SUBJECT: **Addenda No. 1**
Royal Giants Park
2017 Renewal Project
East Spencer

FROM: Ramsay, Burgin, Smith Architects, Inc.
225 North Main Street, Suite 501
Salisbury, NC 28144

SHEET E-1
BE-1
 OF 2

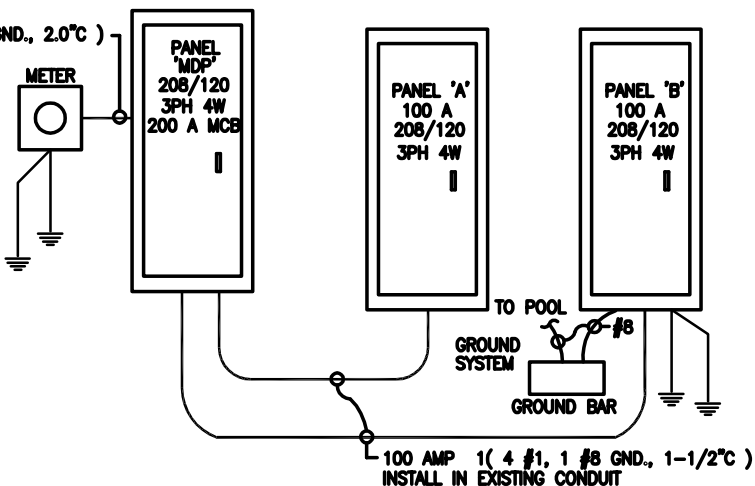
REPLACE EXISTING PANELS WITH NEW PANEL

200 AMP 1(4 #3/0, 1 #8 GND., 2.0°C)
